Please review and comment on the attached request before the Planning Board for a License to Use application for a Puppy Pit Stop at 1 S. Jefferson Street. Please provide comments **by close of business on Friday March 27, 2020**.

Please review the attached AT&T markups. AT&T does have facilities within the project scope. The markups are only approximate and the contractor would have to have our facilities located to determine if there is a conflict. Please contact me with any questions. I am currently working remotely and can be reached at 850-501-9161.

JEFFERSON STREET  
PUPPY PIT STOP

UTILITY PLAN

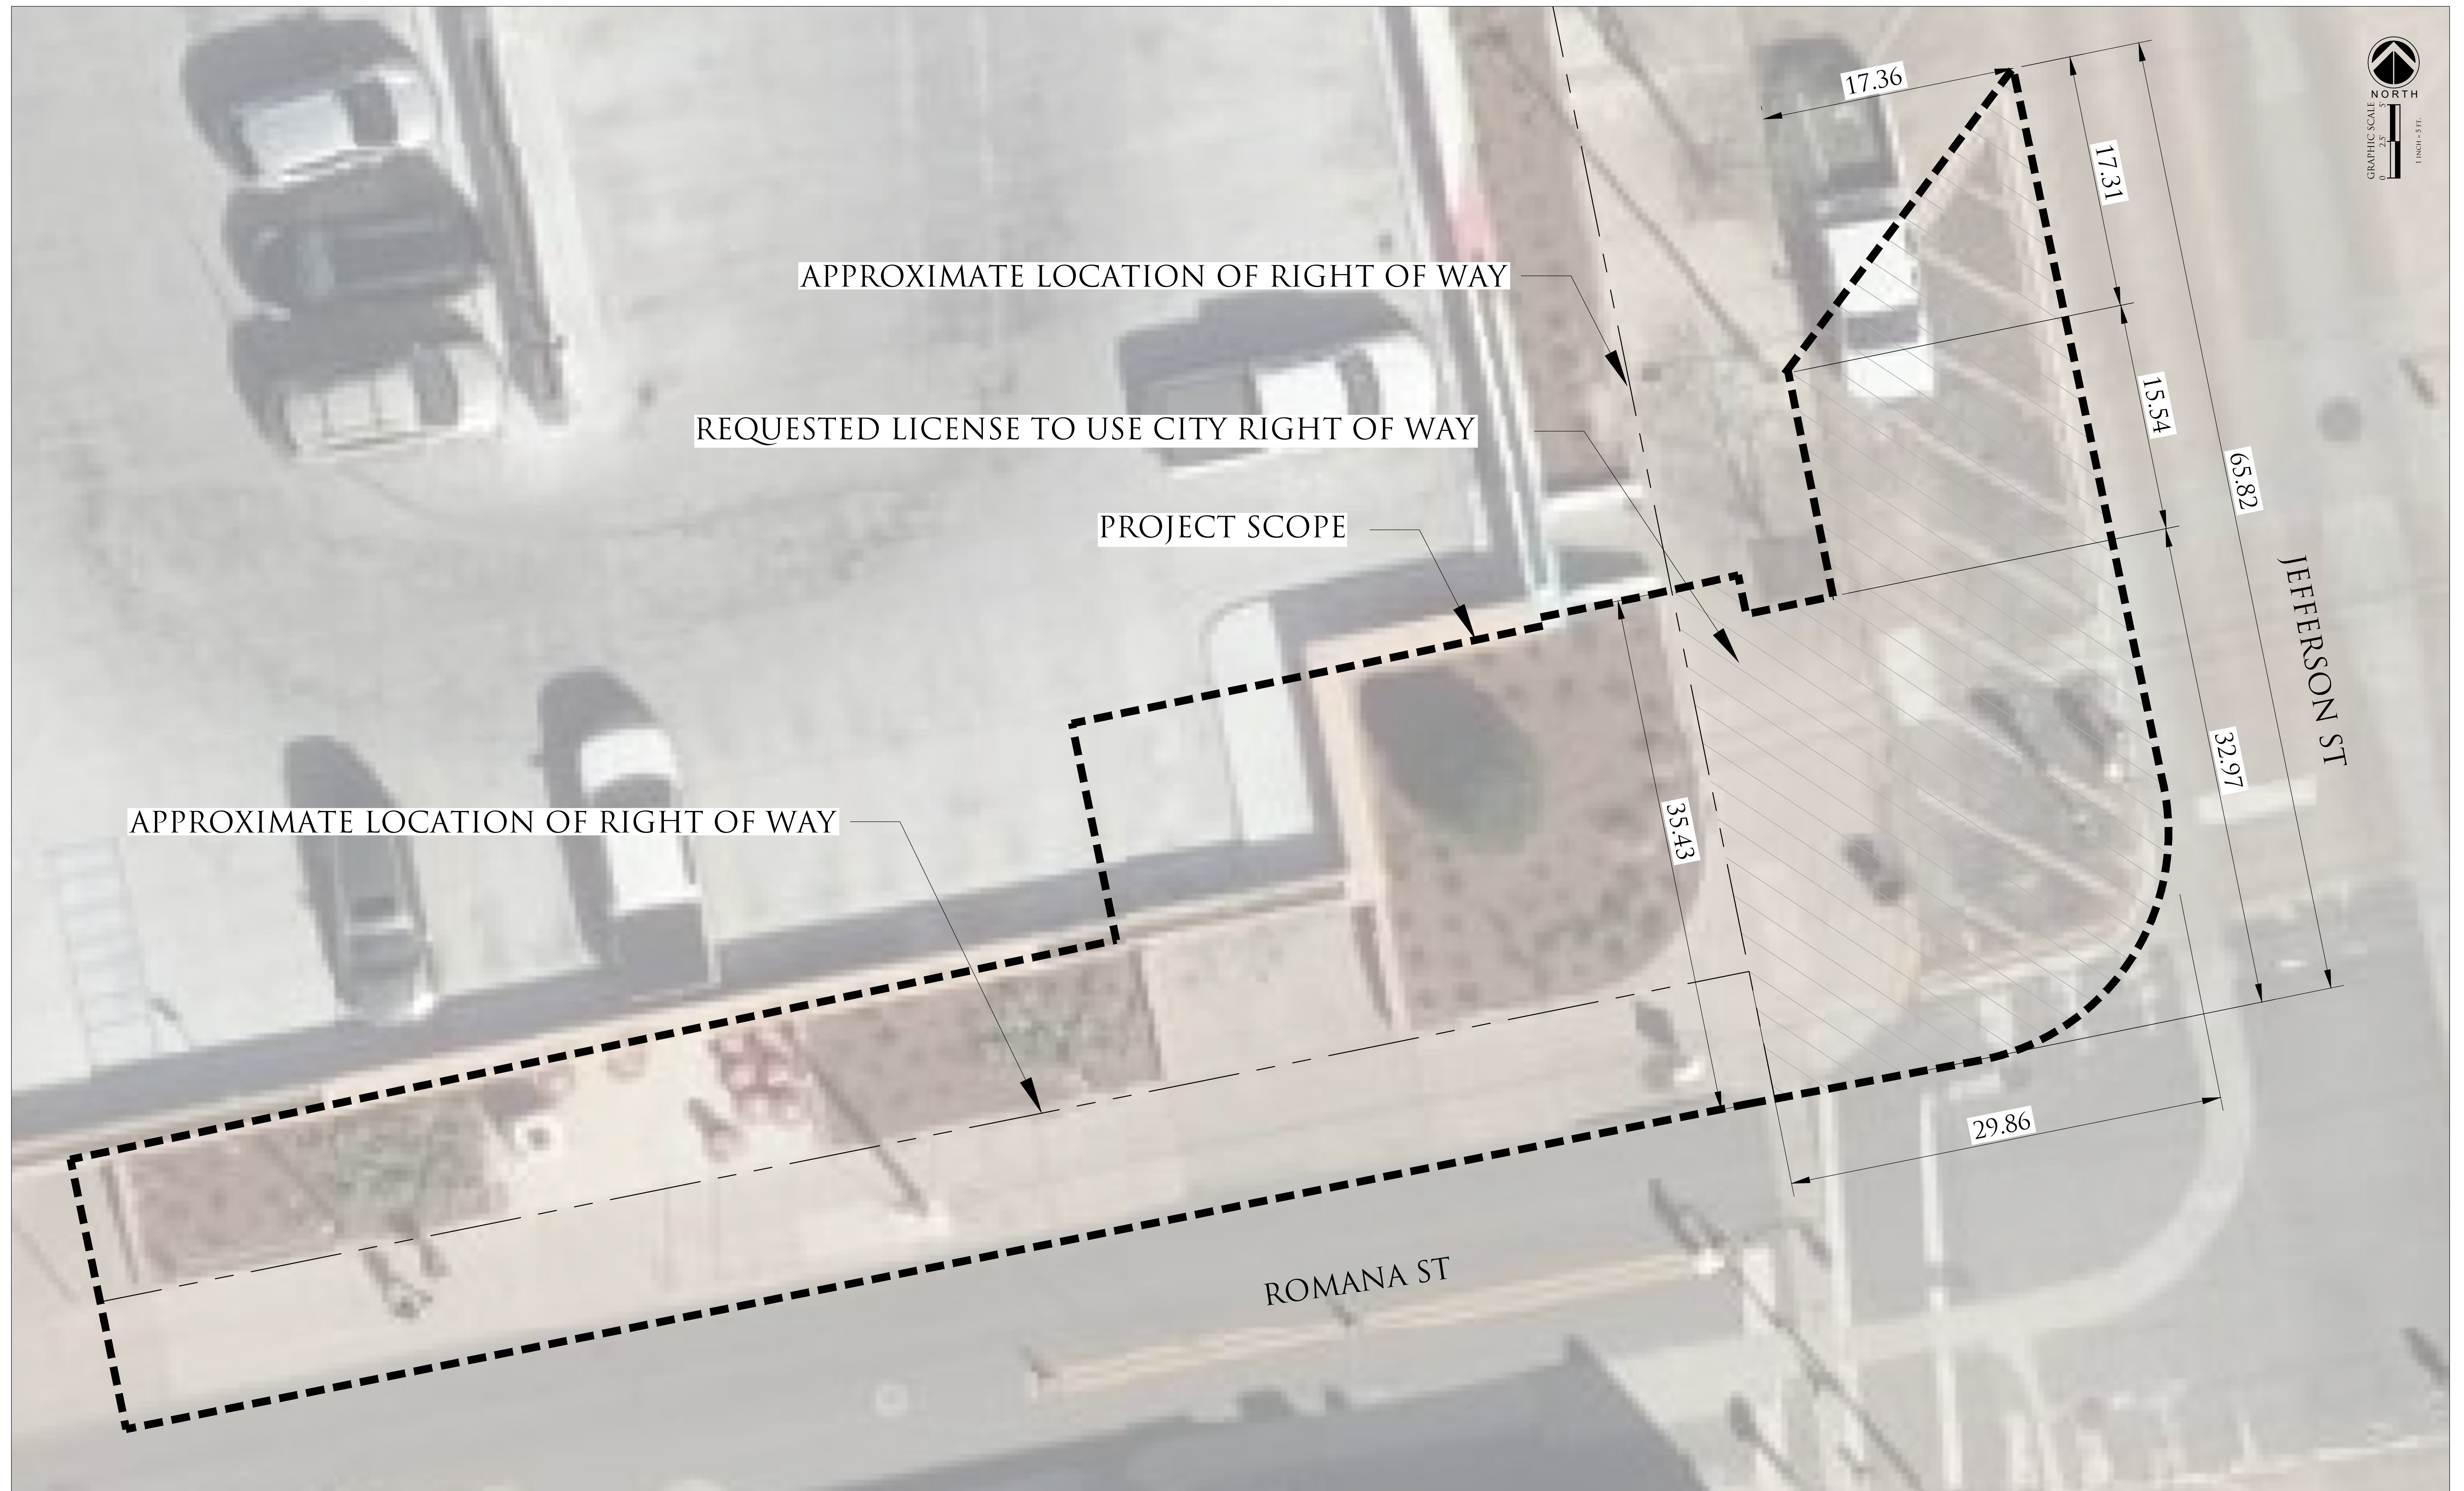
Good morning Rob, this is Elsie Zhang with Jerry Pate Design. I just received the markup from AT&T with potential conduit conflict.

It seems most of the area where the conduit runs is only going to be painted on the existing concrete. The only possible conflict area is around the proposed circular concrete bench area. Do you think field locating the conduit and sleeving it in concrete footer if there is a conflict will be ideal for AT&T?

Cynthia, we will field locate the AT&T conduit and sleeve it in concrete footer if there is a conflict. Do we need to add the note on the plan and resubmit it to you? Or do we wait until we receive other comments?

Yes, if there is a conflict protecting it with a concrete footer is fine.

C-100

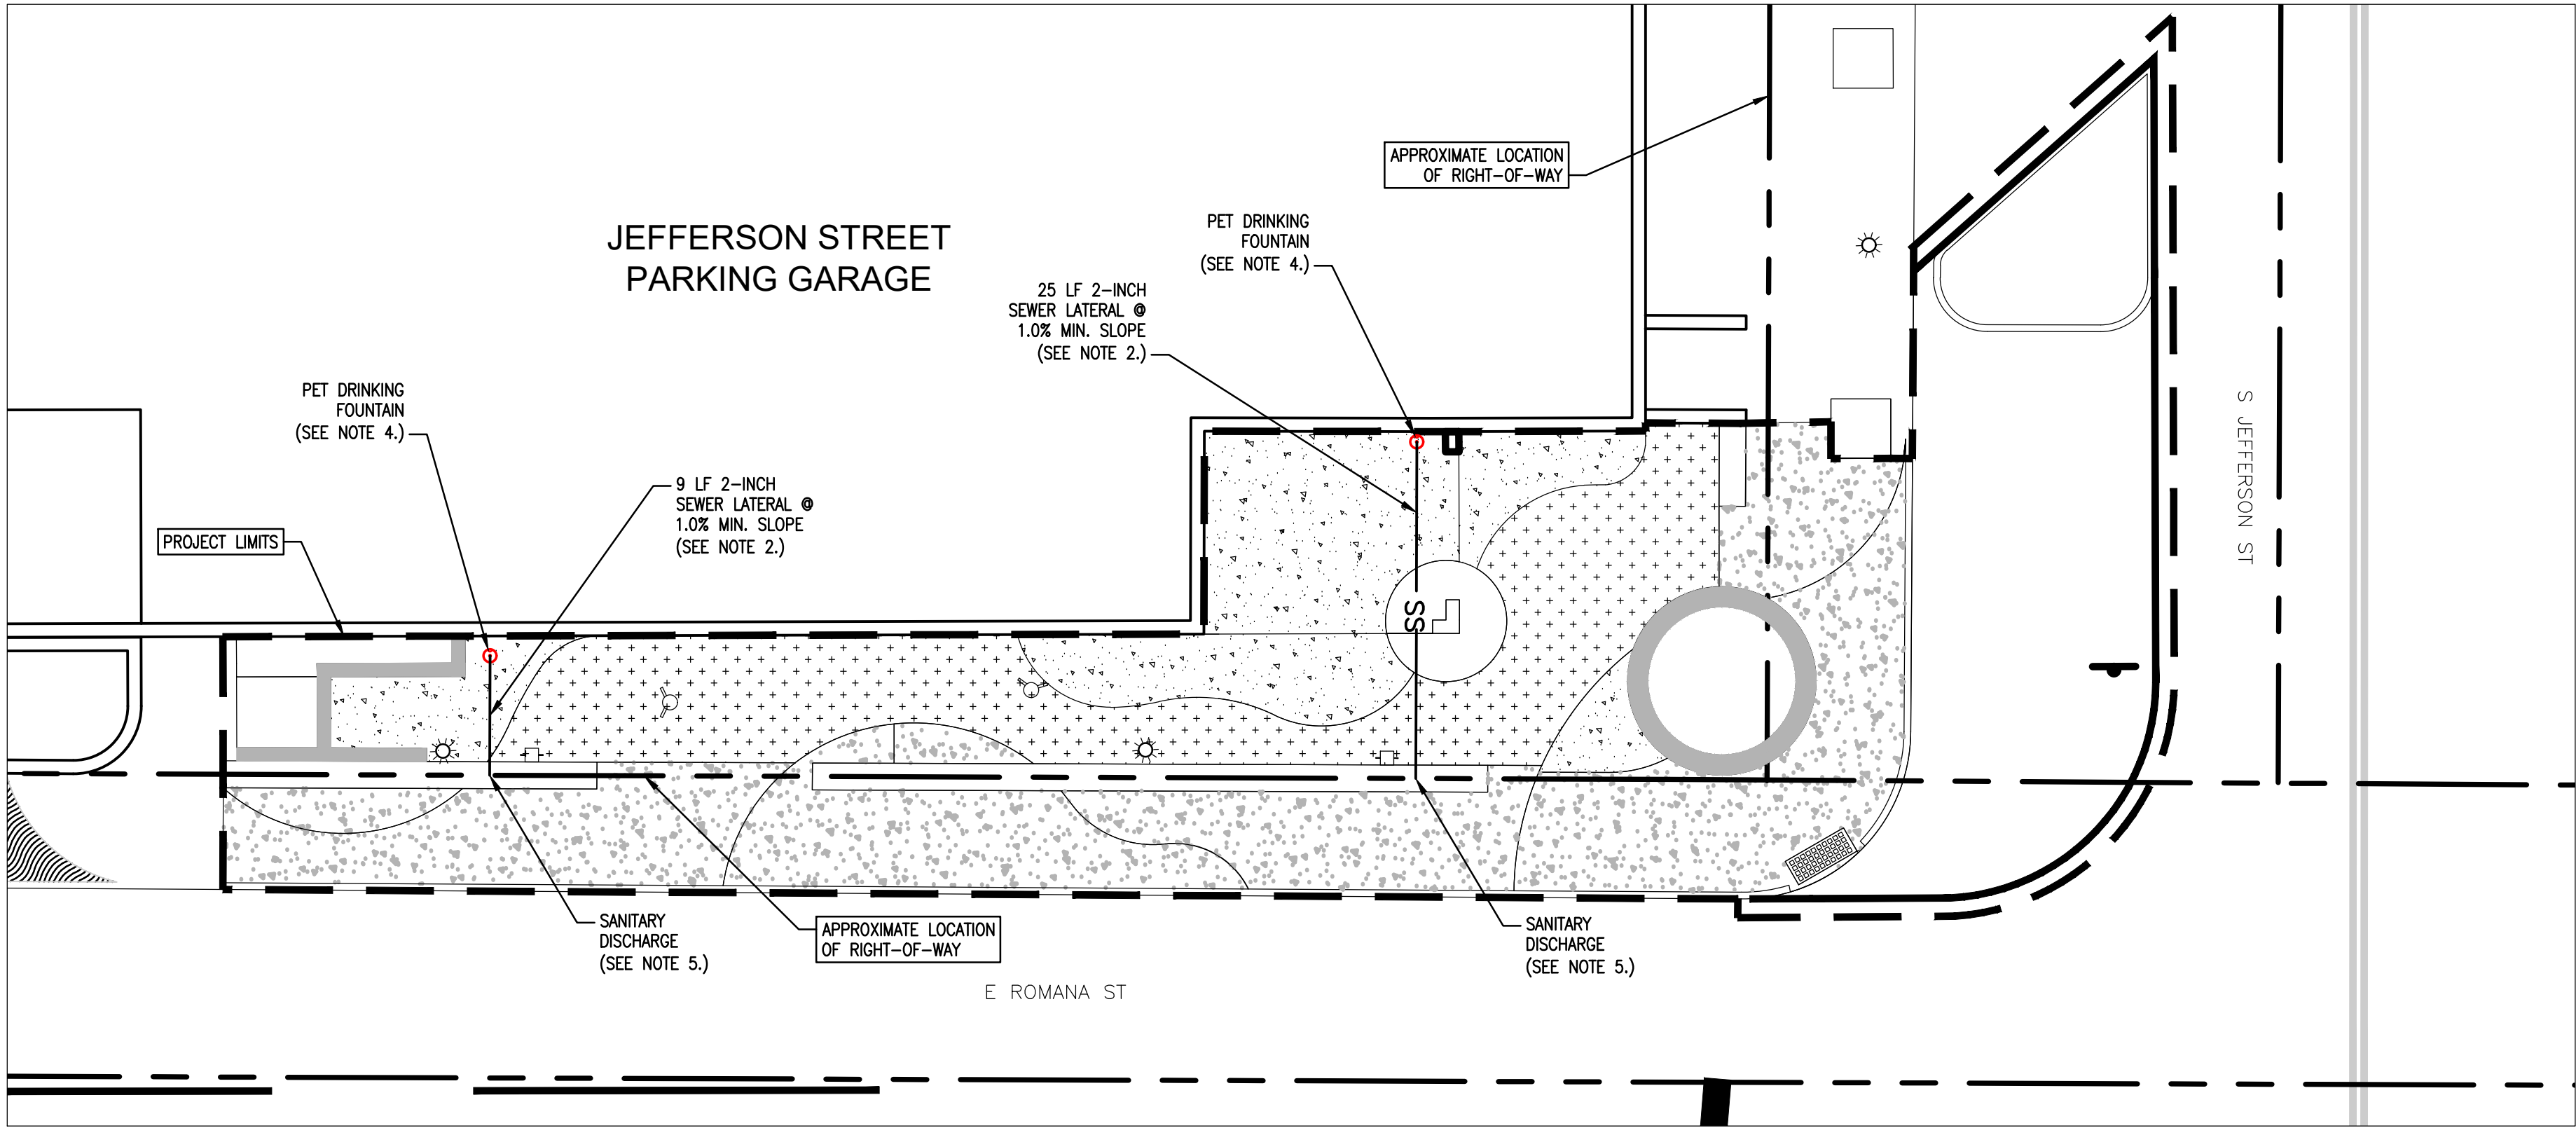
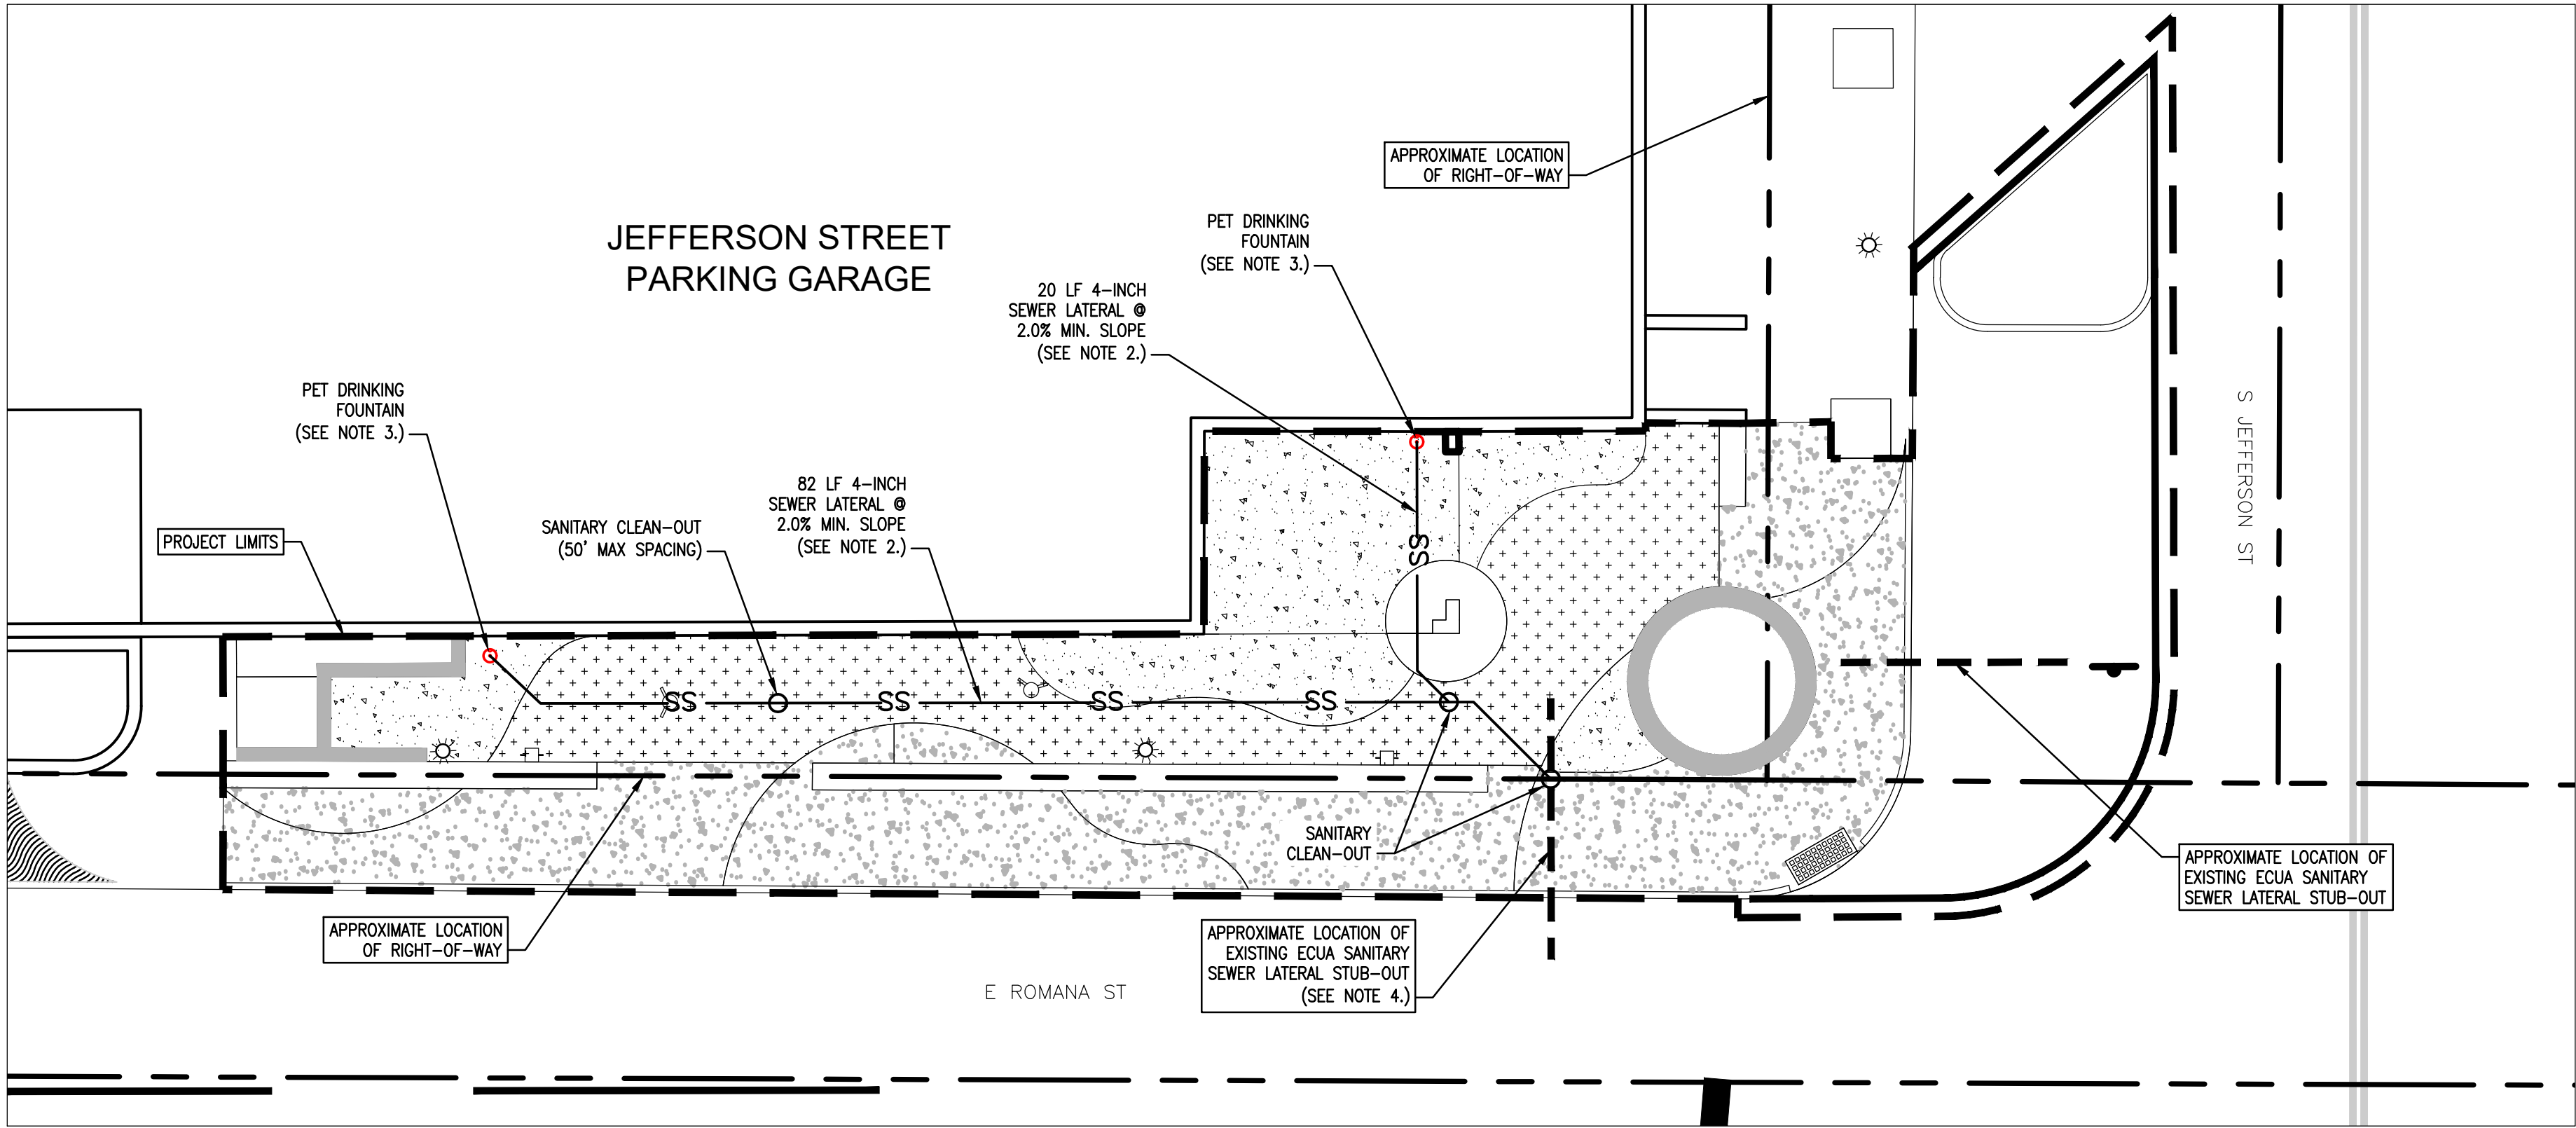
Cynthia,  
Pensacola Energy has a gas main within the R/W described in this LTU request. We would need to know more about the project and the potential impact in maintaining our gas line.

Project will need to submit to ECUA Engineering for review and permitting of water and/or sewer. Please see the ECUA Engineering Manual - Procedures 2 and 3 for information regarding submittal and review processes (<https://ecua.fl.gov/work-with-us/engineering-manuals-contacts>).

- ALL LANES SHALL BE OPEN FOR TRAFFIC IN THE EVENT OF AN EVACUATION NOTICE.
- CONTRACTOR SHALL FIELD LOCATE GAS LINE AND AT&T CONDUIT AND COORDINATE WITH PENSACOLA ENERGY OR AT&T IF THERE IS A CONFLICT BETWEEN THE PROPOSED CONSTRUCTION AND GAS LINE OR AT&T CONDUIT.
